Access Compliance Report

Public Rights-of-Way

Intersection ID: 31292	Main Street: DEERTON_RD	Cross Street: MUNSING_DR	Location: NW
ADA ID: 14F6326B4295	Ramp Type: PerpDiag	Initial Pass/Fail: Fail	Overall Compliance: No
			Severity Score: 21.25

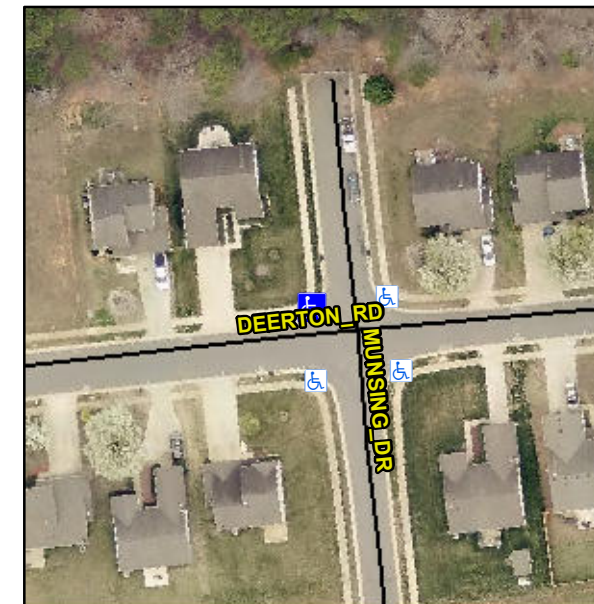
R304.5.1, R304.2.2

Compliance	Description	Data	Compliance	Description	Data
N/A	Ramp Length (in)	50.0	No	Ramp Slope (%)	8.8
No	Ramp Width (in)	37.0	Yes	Ramp XSlope (%)	1.8
N/A	Flare Type LT	N/A	N/A	Flare Type RT	N/A
N/A	Flare Slope LT (%)	N/A	N/A	Flare Slope RT (%)	N/A
N/A	Flare Traversable LT?	N/A	N/A	Flare Traversable RT?	N/A
N/A	Landing Length (in)	N/A	N/A	DWS Provided?	N/A
N/A	Landing Width (in)	N/A	N/A	DWS Contrast?	N/A
N/A	Landing Slope (%)	N/A	N/A	DWS Length (in)	N/A
N/A	Landing X Slope (%)	N/A	N/A	DWS Full Width?	N/A
N/A	Landing Curb? (Y/N)	N/A	N/A	DWS Offset (in)	N/A
N/A	Shared Landing?	N/A			
N/A	Gutter Ponding?	N/A	N/A	Gutter Slope (%)	N/A
N/A	Gutter Lip Ht (in)	N/A	N/A	Gutter X Slope (%)	N/A
N/A	Painted X Walk1?	No	N/A	Painted X Walk2?	No
	X Walk 1 Direction	To E		X Walk 2 Direction	To S
N/A	X Walk 1 Width (in)	N/A	N/A	X Walk 2 Width (in)	N/A
	X Walk 1 Slope (%)	2.3		X Walk 2 Slope (%)	1.8
	X Walk 1 X Slope (%)	2.9		X Walk 2 X Slope (%)	0.7

Remove & Replace Curb Ramp With Two New Directional Ramps or Equivalent.
